Simulink/Front Model & MEDM Screen Mods from ECR E1300578 (For SUS' in BSC Chambers)

J. Kissel for the SUS and ISC Team

G1301192-v3

Removal of ISI OFFLOAD

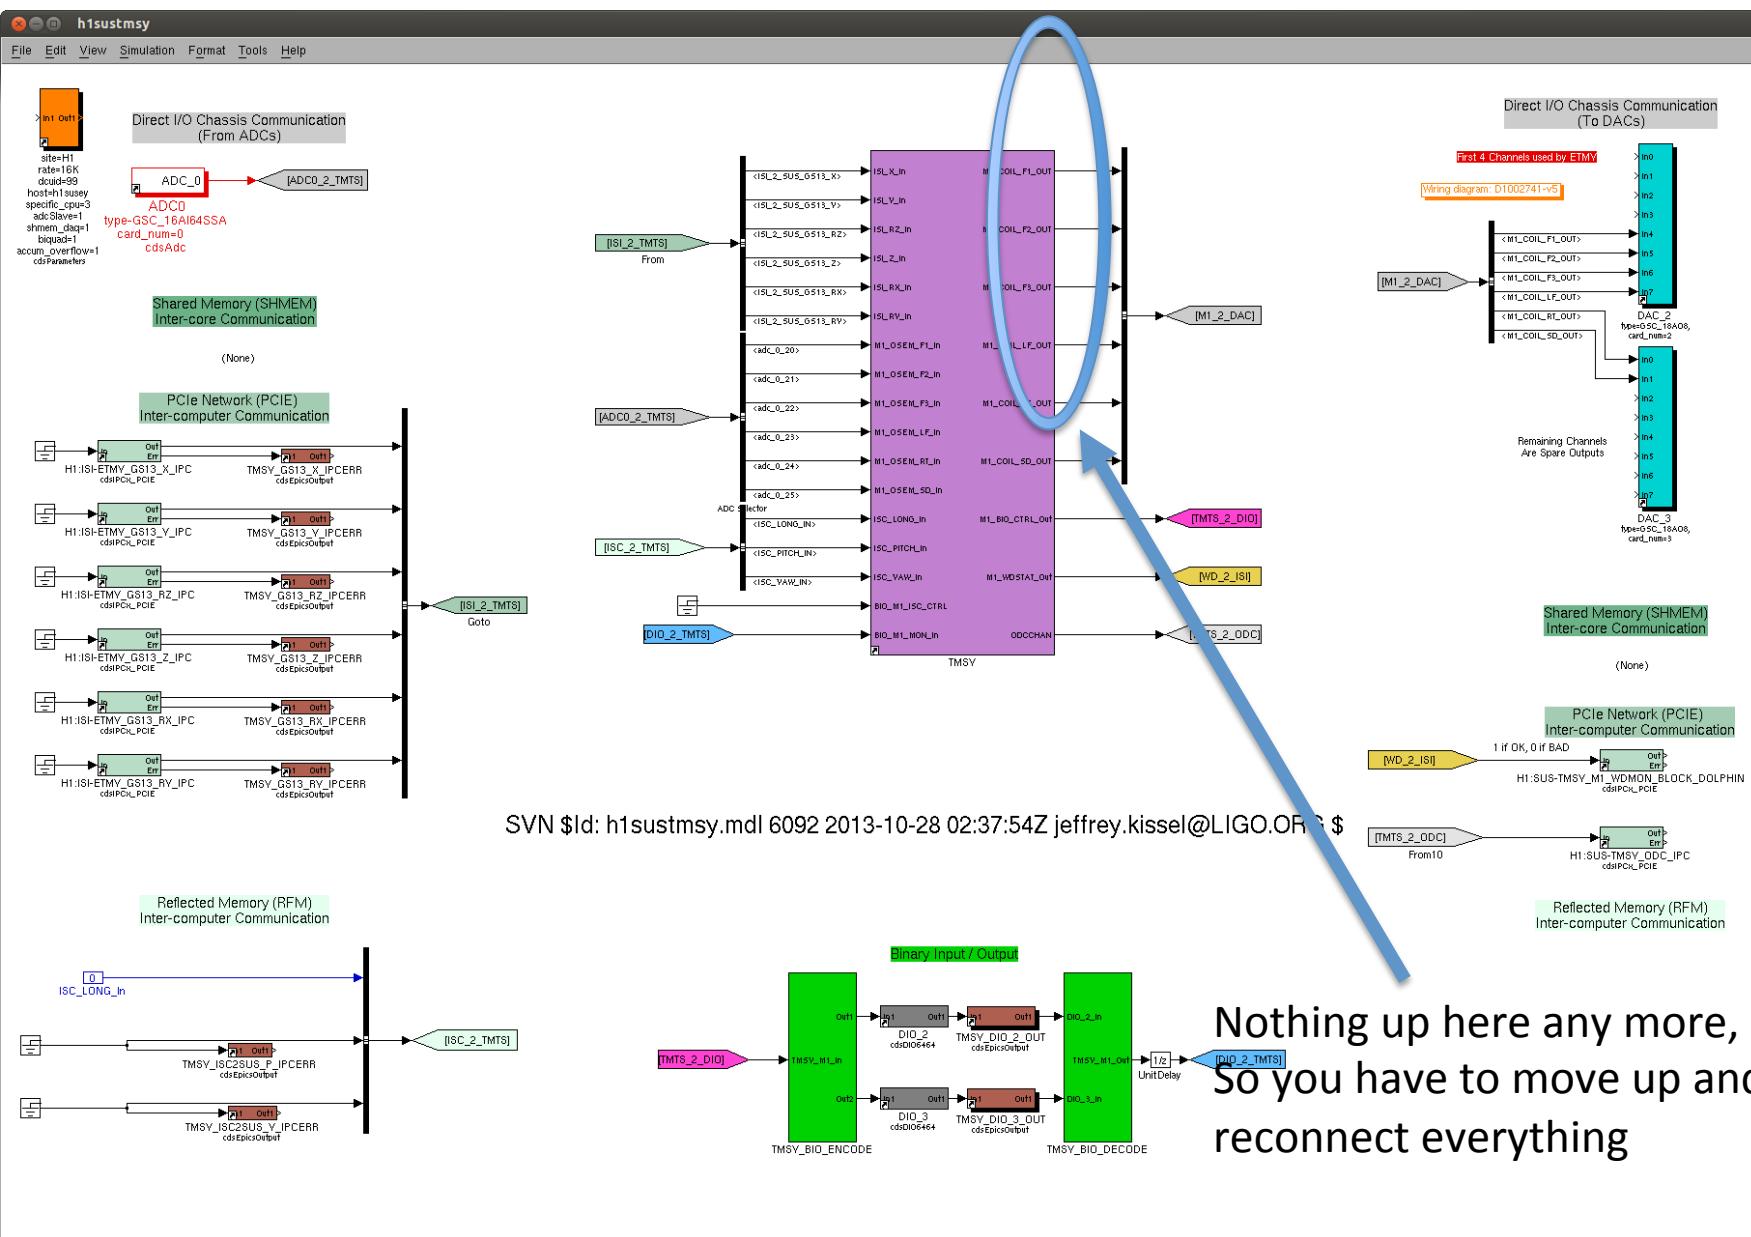
- A part of reducing wasted computation cycles
- Experience has shown that ISC offloading is only needed up to TOP mass of each suspension
- **Affects top-level of models**, so every model must be reconnected and IPCs senders removed
- **SEI needs to get rid of their IPC receivers**
- No longer anything here (for every suspension type)

DRIVEALIGN Mods

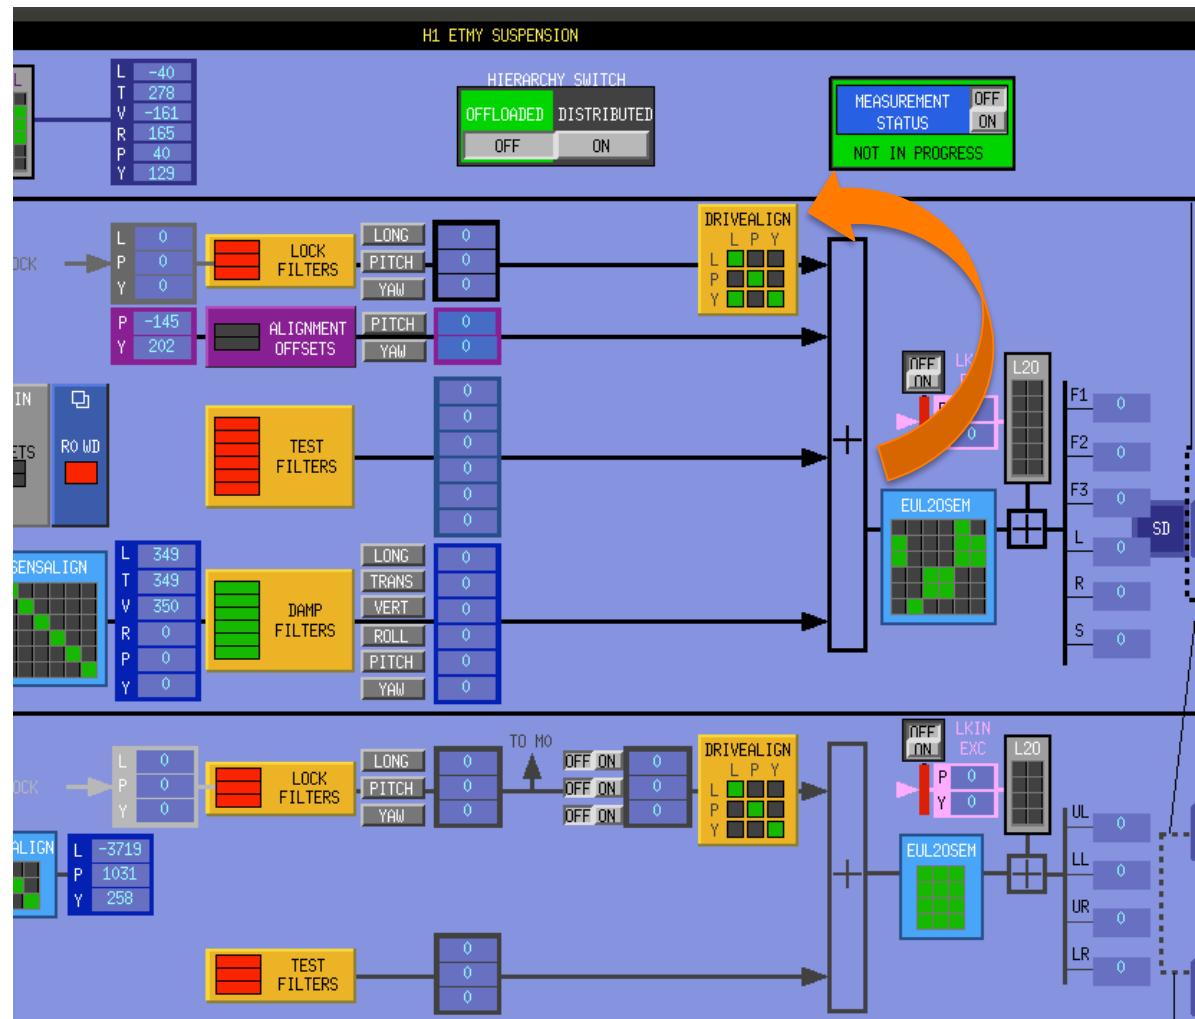
- Move drive align to only affect ISC / “LOCK” Filters
- DRIVEALIGN designed to decouple L, P, and Y force and torque at each stage from L of the optic (the main chain on the QUAD), so it doesn't make sense to include these filters in, say the damping path
- The means
 - Move it up to only affect LOCK path at every stage
 - Reduce the size of M0 M1 matrix from 6x6 to 3x3
 - Totally removed from R0
- Only involves library parts => Comes for free with update

Added ODC Bits

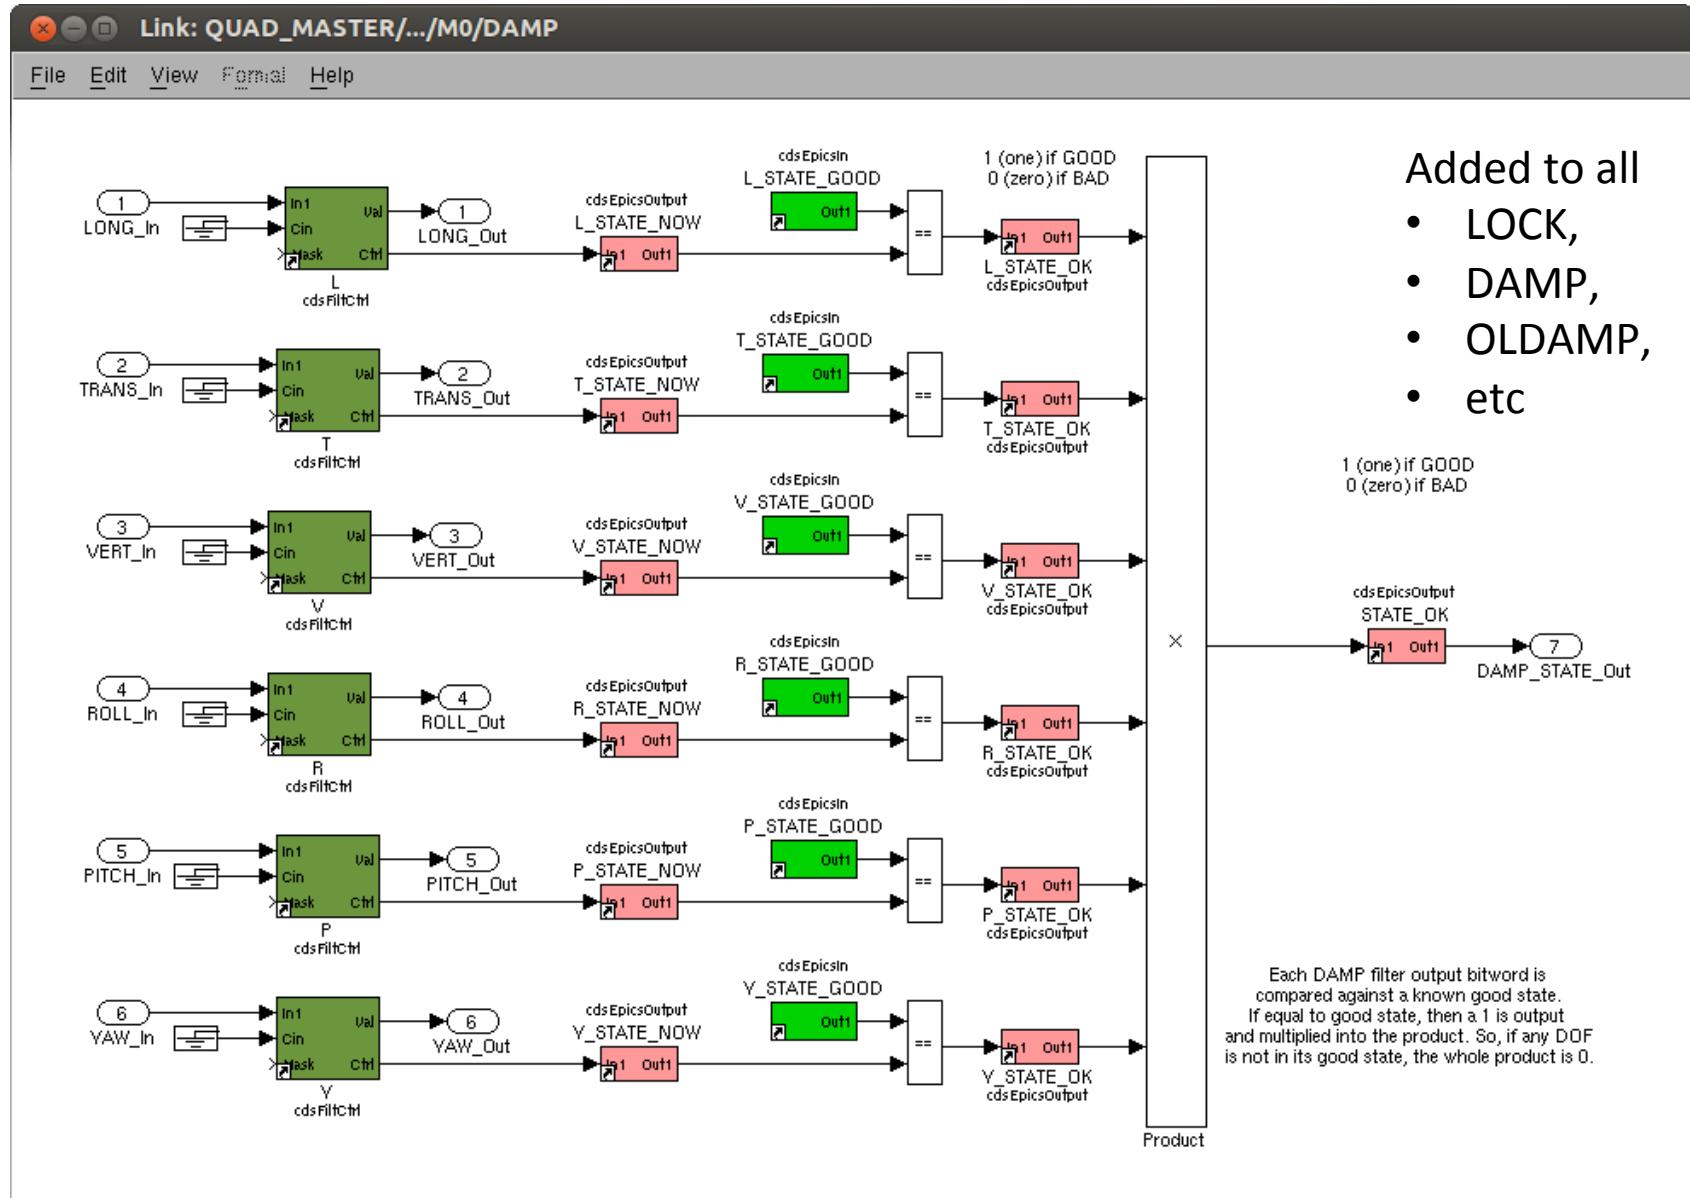
- State logic is now on every one of the DAMP, LOCK, OLDAMP filter screens
- Only includes filter modules in the state, no gains 😞
- Thought about doing this for OSEMINFs, but they need unique gain number for every OSEM, so not compatible with library parts

Added ODC Bits

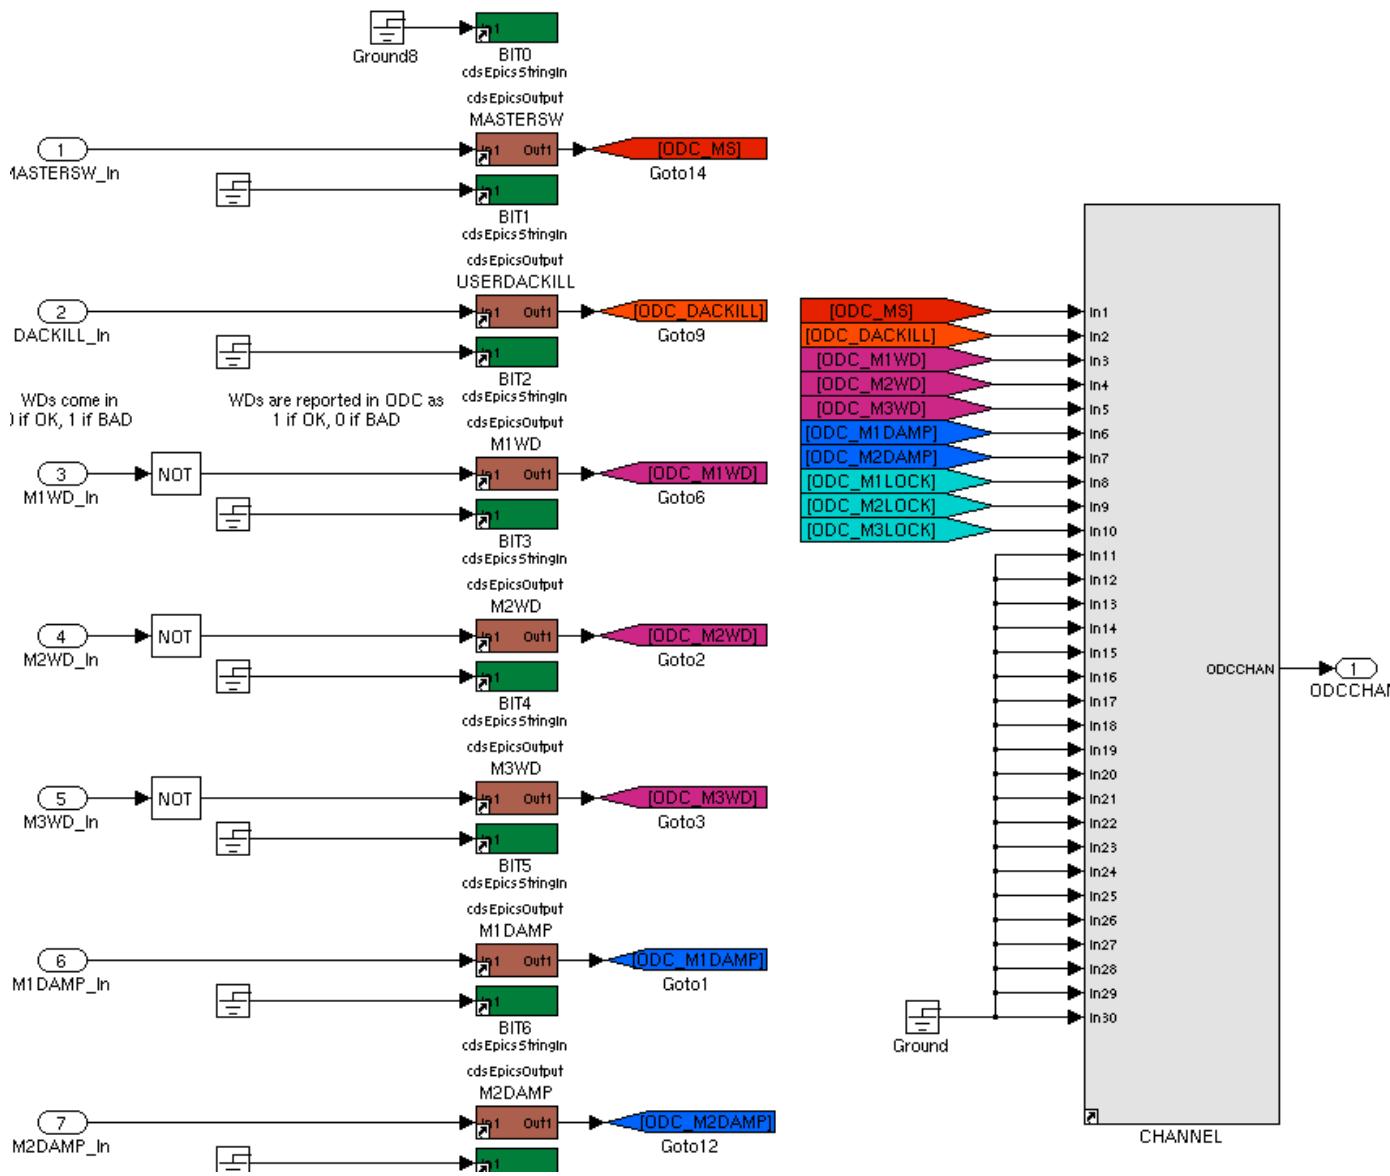
All bits get piped into new ODC V2 Block which is much cleaner

Added ODC Bits

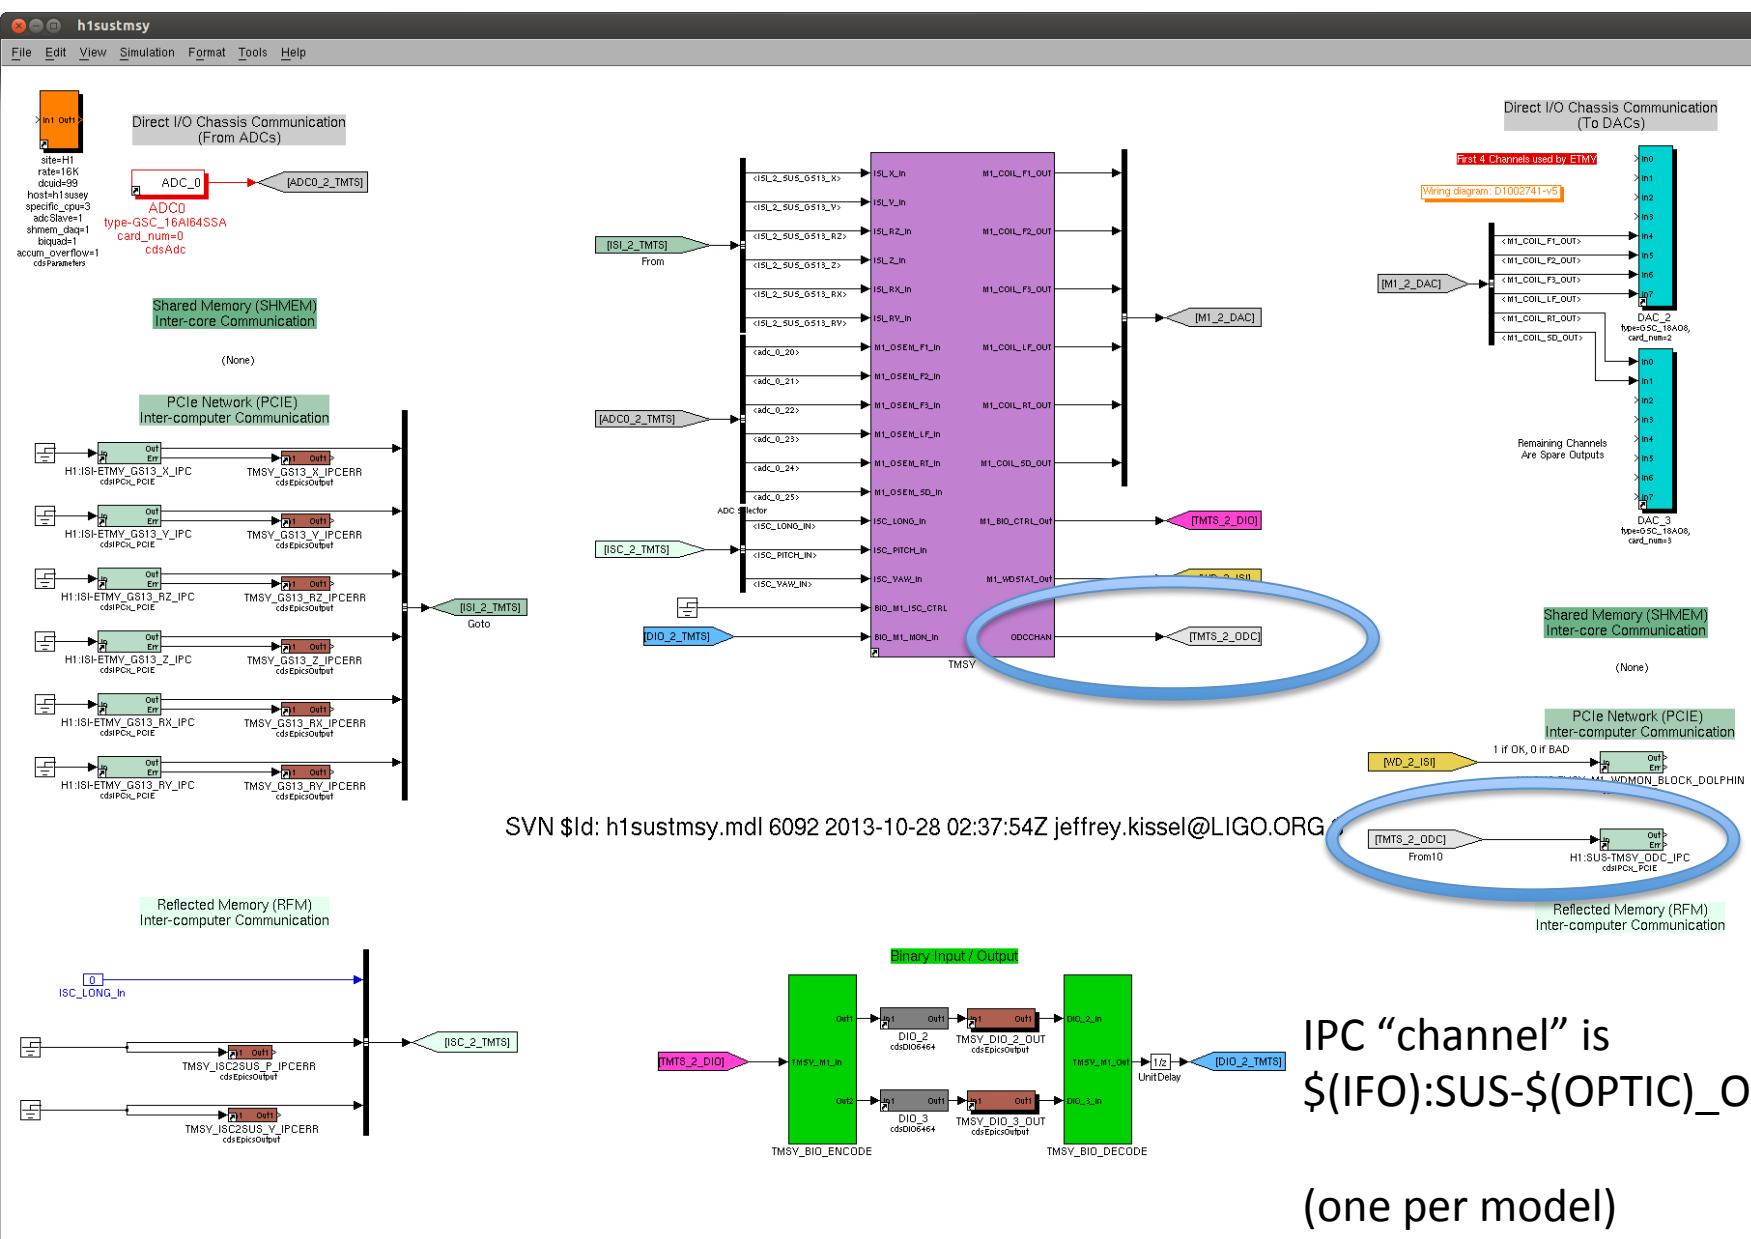
QUADs have 13 bits,
BSFMs have 10 bits,
TMTSs have 5 bits,
Etc. depending on
how many stages of
LOCKing and
DAMPing

Channel is now spit out to the top level
to be collected by
ODC master

Affects top models!

Added switch after ISC (internal) OFFLOAD

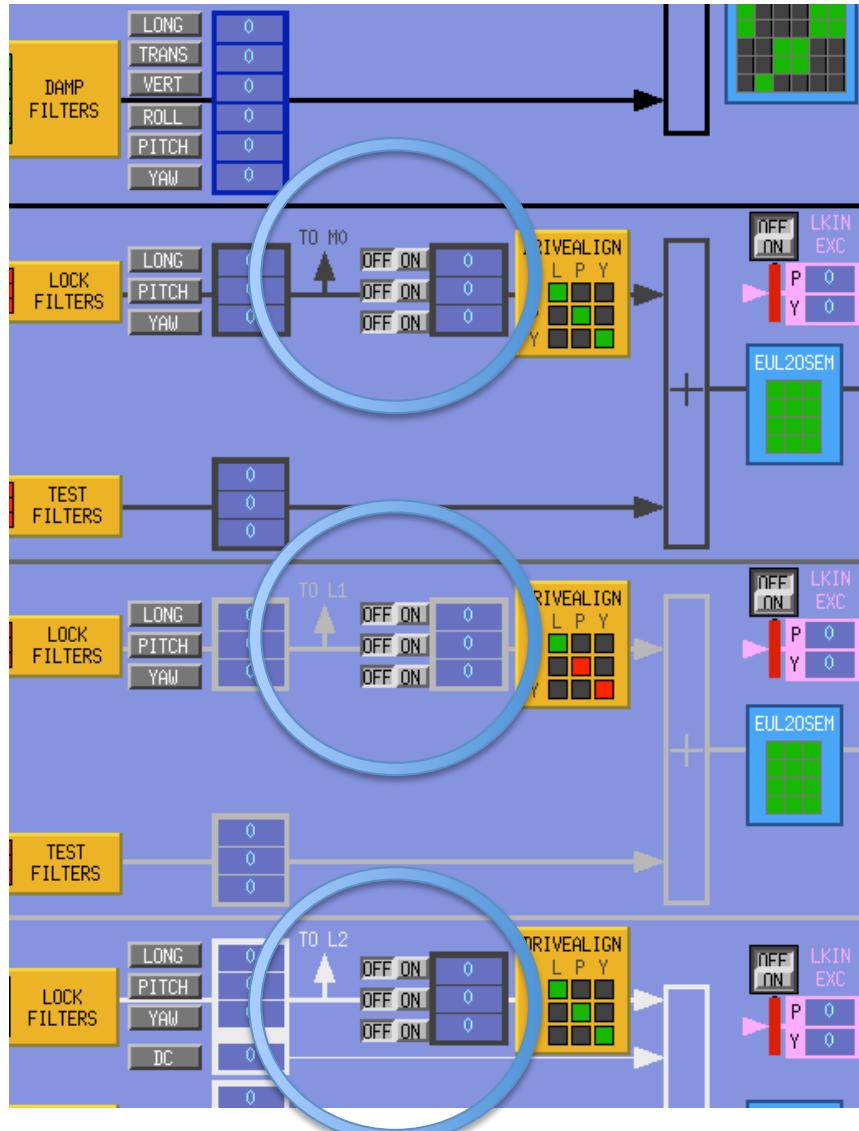
- Added independent on/off switch between offload to upper stages and the DRIVEALIGN matrix
- This is so when we use “offloaded” (as opposed to “distributed”) hierarchy, we can pipe the ASC signals up to only the TOP mass, as opposed to LSC which needs to go to every stage
